Kansas Department of Agriculture
 Division of Water Resources
CHANGE: P/U WORKSHEET

**DWR FIELD OFFICE
 APPLICATION FOR APPROVAL
 TO CHANGE THE PLACE OF
 USE AND/OR THE
 POINT OF DIVERSION**

File No. 8429

EQUUS BEDS GROUNDWATER MANAGEMENT DISTRICT NO. 2 FINAL APPLICATION REVIEW CHECKLIST

CHANGE IN PLACE OF USE APPLICATION MAP

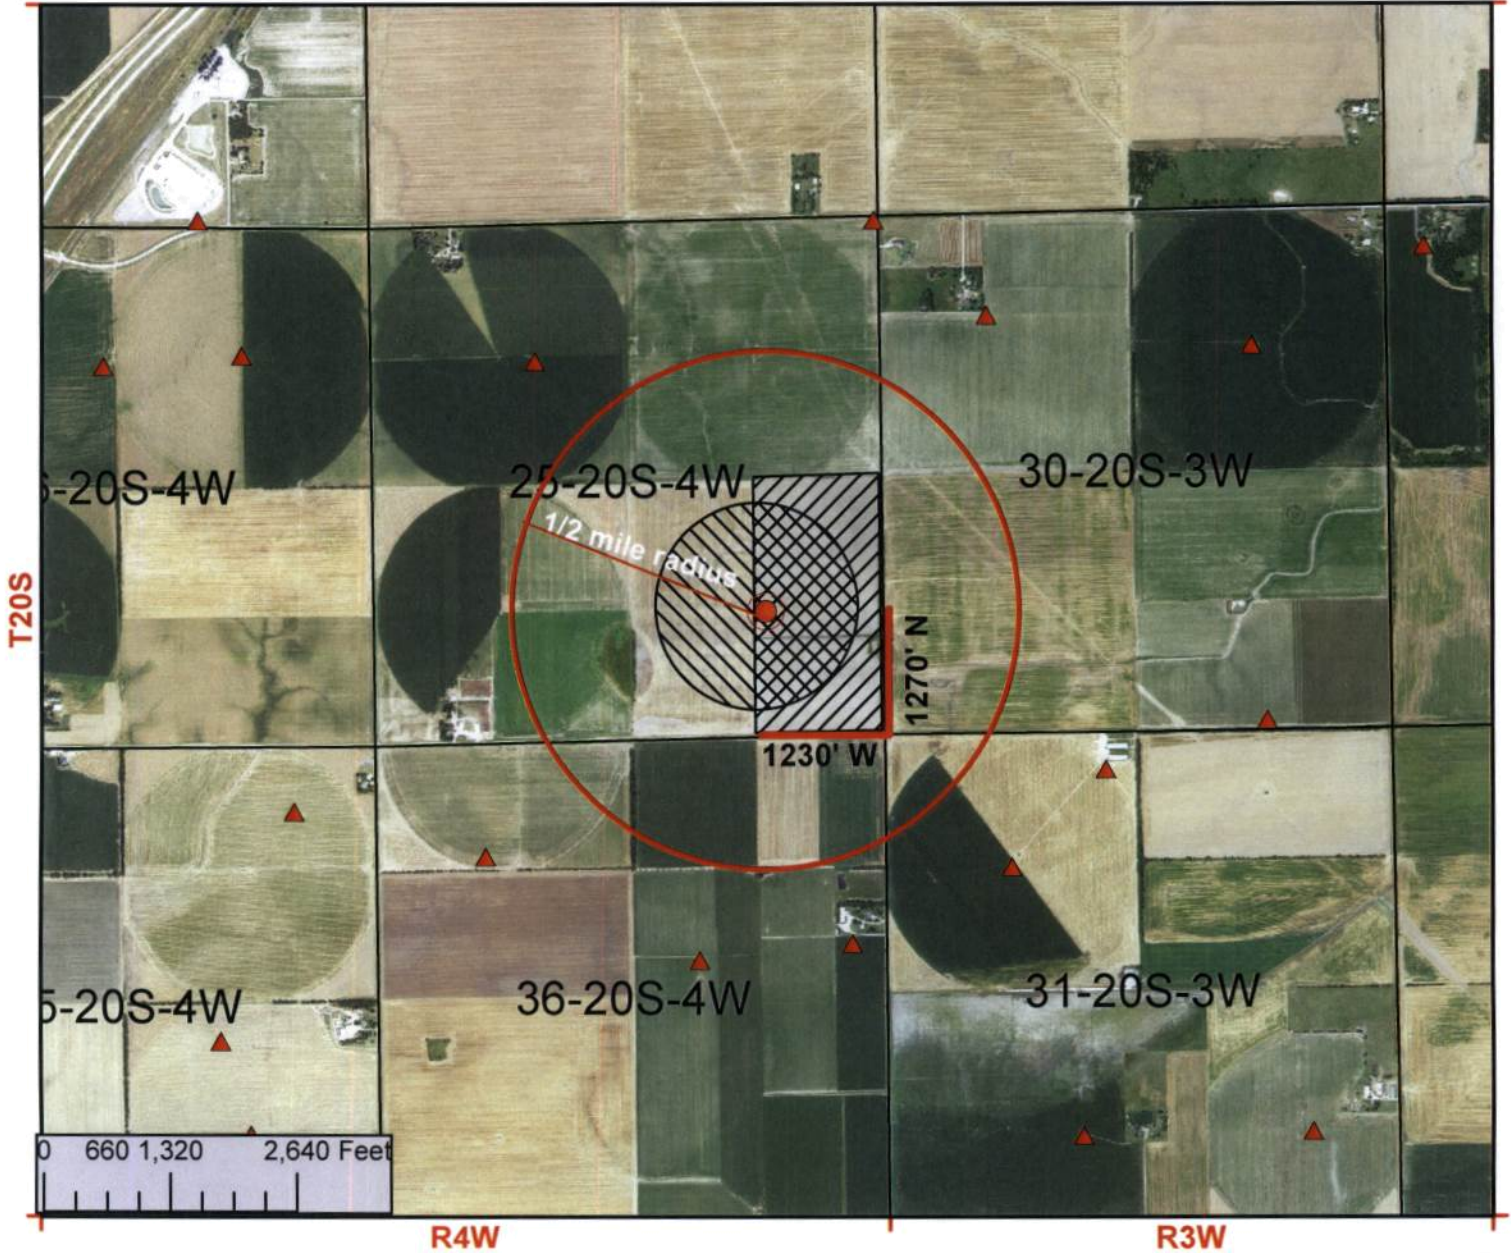
No wells within 1/2 mile
